Access Compliance Report

Public Rights-of-Way

(Curb Ramps)

Intersection ID: 25142	Main Street: COTTON_CREEK_DR	Cross Street: WEAVER_MILL_LN	Location: S
ADA ID: DB8964A8481C	Ramp Type: PerpDiag	Initial Pass/Fail: Fail	Overall Compliance: No
Severity Score: 33.75			
Codes/Mitigation Info/Possible Solution		Field Measurements/Component Compliance

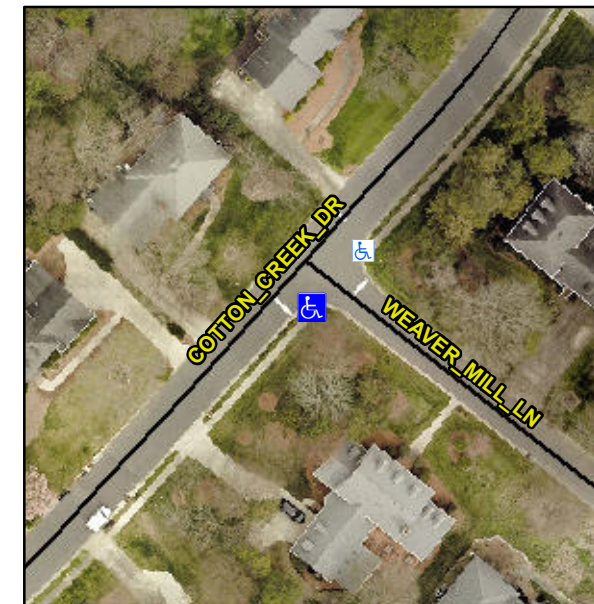
Not Found, R304.5.1, R304.2.2, R304.5.3

Compliance	Description	Data	Compliance	Description	Data
N/A	Ramp Length (in)	53.0	No	Ramp Slope (%)	9.9
No	Ramp Width (in)	37.0	No	Ramp XSlope (%)	5.5
N/A	Flare Type LT	N/A	N/A	Flare Type RT	N/A
N/A	Flare Slope LT (%)	N/A	N/A	Flare Slope RT (%)	N/A
N/A	Flare Traversable LT?	N/A	N/A	Flare Traversable RT?	N/A
N/A	Landing Length (in)	N/A	N/A	DWS Provided?	N/A
N/A	Landing Width (in)	N/A	N/A	DWS Contrast?	N/A
N/A	Landing Slope (%)	N/A	N/A	DWS Length (in)	N/A
N/A	Landing X Slope (%)	N/A	N/A	DWS Full Width?	N/A
N/A	Landing Curb? (Y/N)	N/A	N/A	DWS Offset (in)	N/A
N/A	Shared Landing?	N/A			
N/A	Gutter Ponding?	N/A	N/A	Gutter Slope (%)	N/A
N/A	Gutter Lip Ht (in)	N/A	N/A	Gutter X Slope (%)	N/A
N/A	Painted X Walk1?	No	N/A	Painted X Walk2?	No
	X Walk 1 Direction	To NE		X Walk 2 Direction	To NW
N/A	X Walk 1 Width (in)	N/A	N/A	X Walk 2 Width (in)	N/A
	X Walk 1 Slope (%)	4.0		X Walk 2 Slope (%)	3.6
	X Walk 1 X Slope (%)	6.1		X Walk 2 X Slope (%)	2.1

N/A	Ramp inside XWalk1?	N/A	N/A	Ramp inside XWalk2?	N/A
	Road Slope (%)	2.2	N/A	Clear Space?	N/A
	Road X Slope (%)	7.2	N/A	Clear Space to XWalk (in)	N/A
N/A	Any Obstructions?	N/A	N/A	Storm Grate/Utility Hazard?	N/A
	Obstruction Type			Storm Grate/Utility Type	
		N/A			N/A
			Yes	Surface Condition? (G/P)	Good

Remove & Replace Curb Ramp With Two New Directional Ramps or Equivalent.
